UNITED STATES PATENT AND TRADEMARK OFFICE

APPLICATION NO.	FILING DATE	FIRST NAMED INVENTOR	ATTORNEY DOCKET NO.	CONFIRMATION NO.
10/590,587	10/25/2006	Hideki Watanabe	S004-5852 (PCT)	8549
7590 Bruce L. Adams Adams & Wilks 17 Battery Place-Suite 1231 New York, NY 10004			EXAMINER COLILLA, DANIEL JAMES	
			ART UNIT 2854	PAPER NUMBER
			MAIL DATE 06/25/2010	DELIVERY MODE PAPER

Office Action Summary

DETAILED ACTION

rotationally driving the platen roller 6 as shown below in the figure taken from Fig. 8 of

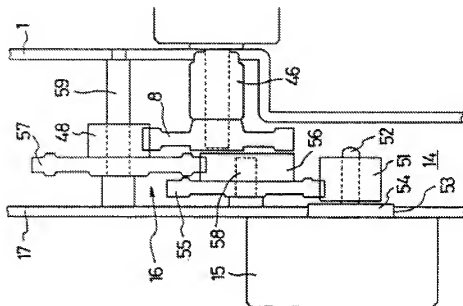
With respect to claim 7, Saito *et al.* discloses a printer, comprising:

a main frame 1,2,3 having two spaced-apart opposed side

walls 1,2;

a platen roller 6 rotatably supported by the two side

walls 1,2 ; a print head 9 disposed opposite the platen roller 6; and a preassembled drive

unit 15,16,17 capable of being mounted in a preassembled state to the side wall 1 for

Saito *et al.* discloses that the preassembled drive unit comprises a support member 17 integrally formed with gear support shafts 58 and 59 (Saito *et al.*, col. 11, lines 5-16), a rotary motor 15 supported by the support member 17 and having a drive gear 51, and idler gears 55 and 57 rotatably mounted on respective gear support shafts 58 and 59 for transmitting rotational movement of the drive gear 51 to the platen roller 6, the drive gear 51 and the idler gears 55 and 57 being disposed in a space defined by the gear support member 17 and the one side wall 1 as shown above.

【図5】

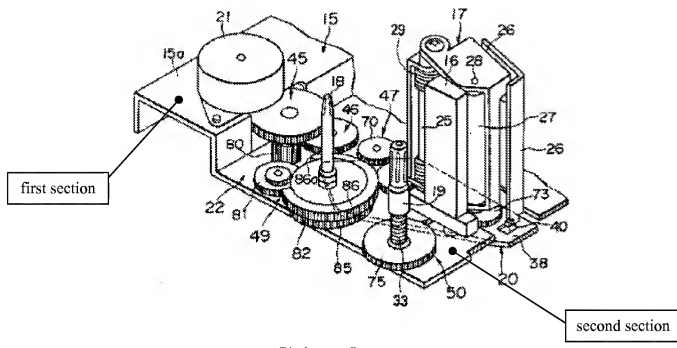
With respect to claim 12, Saito *et al.* discloses the claimed printer except for the first support member section being offset from a second support member section. However, Miyazaki teaches a printer with a motor for driving a platen including a support member having a first section to which the rotary motor 21 is mounted, and a second section offset from the first section and from which gear support shafts extend (although gear support shafts are not shown, the gears must inherently be supported by shafts of some type) as shown below in the Figure taken from Fig. 5 of Miyazaki:

It would have been obvious to combine the teaching of Miyazaki with the printer disclosed by Saito et al. for the advantage of providing the motor and gears on the same side of the support so that they disclosed easily be serviced together.
